STAFF COMMENTS FOR HISTORIC PRESERVATION ADVISORY COMMITTEE

Title: **HAWP-111 – Continuation of Public Hearing**

Request: **Addition**

Address: **100 Central Avenue**

Existing Front Elevation Structure
 100 Central Avenue Gaithersurg MD

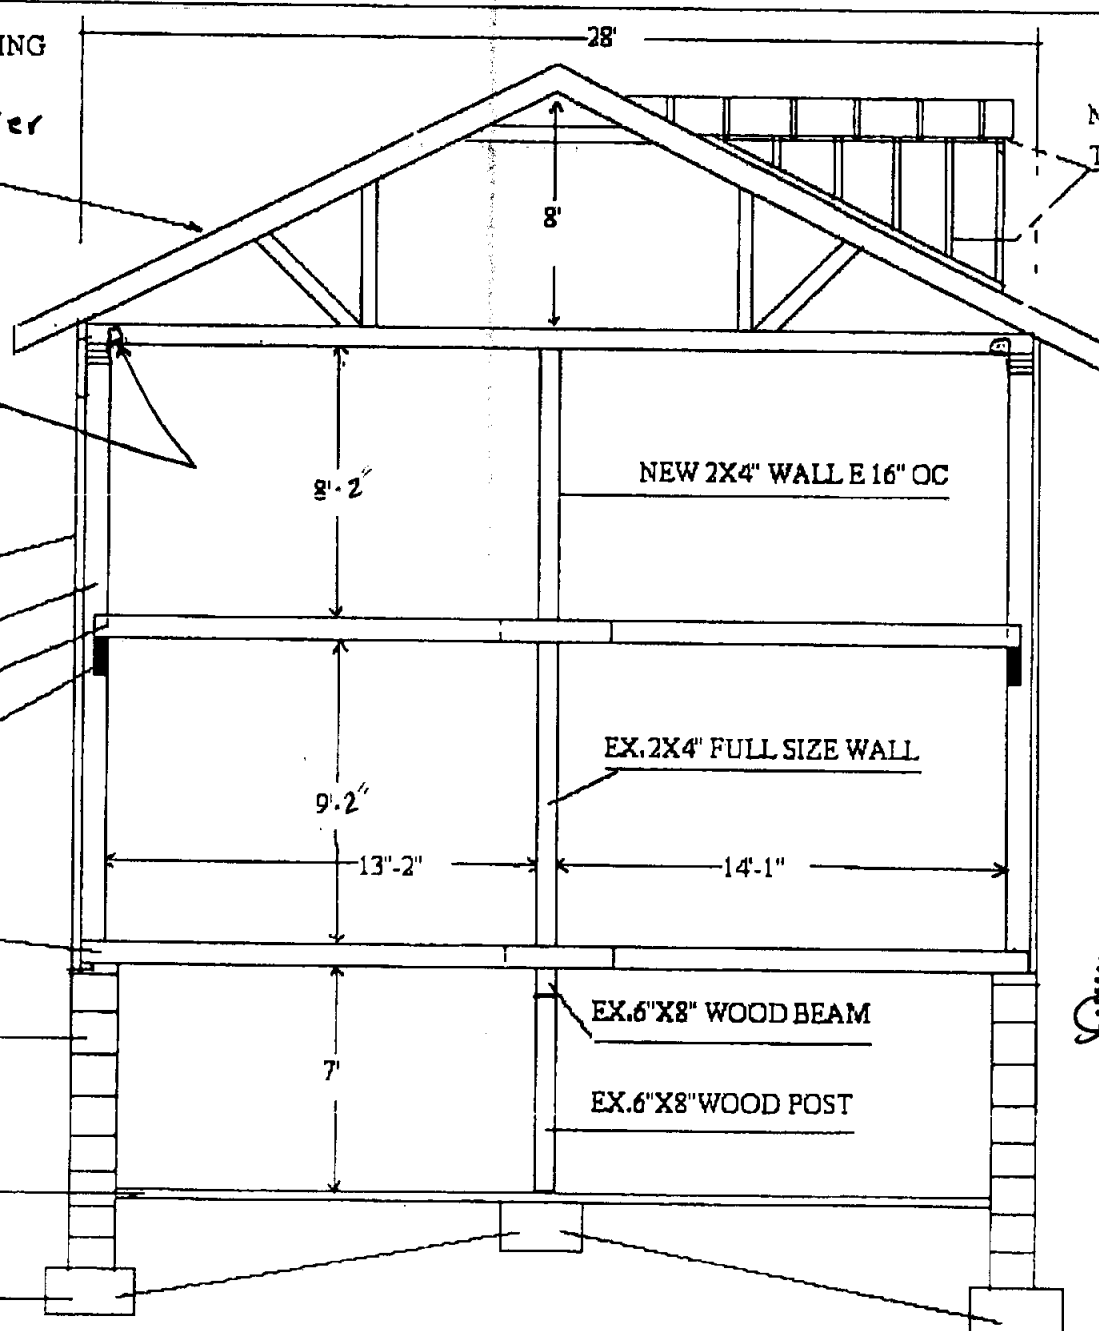
Mr. Coratola stated that the newly built dormer location and its proportions do not seem correct. He said that in general, he needs further documentation and that the drawings are too loosely done. He is looking for drawings which document the existing structure, specify its materials, the addition and addition materials. The addition should have a similar feel to the original structure, but should not copy it directly. The drawings need to be accurate enough so that there is a level of comfort that what is approved by the Committee will be built in the field. He also commented that the front porch columns shown on the plans do not reflect the existing columns.

Mr. Vedadi explained the method that the applicant used to determine the placement and size of the dormer. By using a photo of the original structure and its location on the roof, the applicant was able to estimate the size and placement of the dormer. He also stated that the addition is now setback from the existing house and that the roofline is not on the same plane as the roofline of the existing house, as required previously by the Committee.
